Access Compliance Report

Public Rights-of-Way

(Curb Ramps)

Intersection ID: 11892	Main Street: BOYER_ST	Cross Street: TAGGART_CREEK_RD	Location: NW
ADA ID: 3871B55BD264	Ramp Type: Perp	Initial Pass/Fail: Fail	Overall Compliance: No
Severity Score: 13.75			
Codes/Mitigation Info/Possible Solution		Field Measurements/Component Compliance

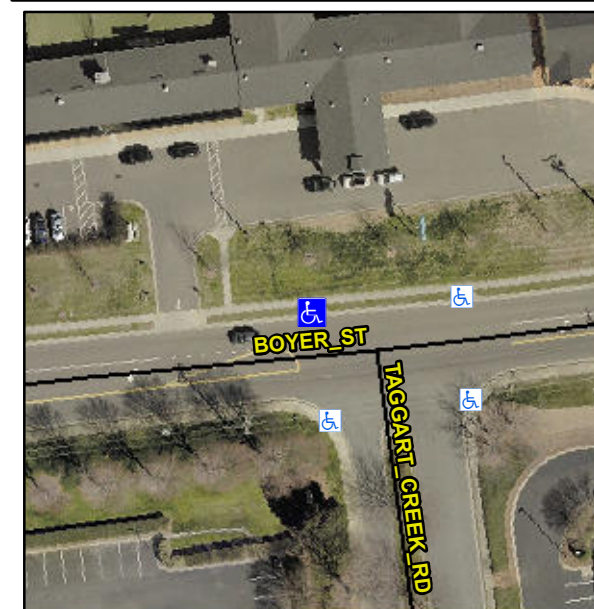
R304.2.2

Compliance	Description	Data	Compliance	Description	Data
N/A	Ramp Length (in)	60.0	No	Ramp Slope (%)	9.1
Yes	Ramp Width (in)	48.0	Yes	Ramp XSlope (%)	2.1
N/A	Flare Type LT	N/A	N/A	Flare Type RT	N/A
N/A	Flare Slope LT (%)	N/A	N/A	Flare Slope RT (%)	N/A
N/A	Flare Traversable LT?	N/A	N/A	Flare Traversable RT?	N/A
N/A	Landing Length (in)	N/A	N/A	DWS Provided?	N/A
N/A	Landing Width (in)	N/A	N/A	DWS Contrast?	N/A
N/A	Landing Slope (%)	N/A	N/A	DWS Length (in)	N/A
N/A	Landing X Slope (%)	N/A	N/A	DWS Full Width?	N/A
N/A	Landing Curb? (Y/N)	N/A	N/A	DWS Offset (in)	N/A
N/A	Shared Landing?	N/A			
N/A	Gutter Ponding?	N/A	N/A	Gutter Slope (%)	N/A
N/A	Gutter Lip Ht (in)	N/A	N/A	Gutter X Slope (%)	N/A
N/A	Painted X Walk1?	No	N/A	Painted X Walk2?	N/A
	X Walk 1 Direction	To S		X Walk 2 Direction	N/A
N/A	X Walk 1 Width (in)	N/A	N/A	X Walk 2 Width (in)	N/A
	X Walk 1 Slope (%)	1.7		X Walk 2 Slope (%)	N/A
	X Walk 1 X Slope (%)	3.1		X Walk 2 X Slope (%)	N/A

Remove & Replace Entire Ramp.
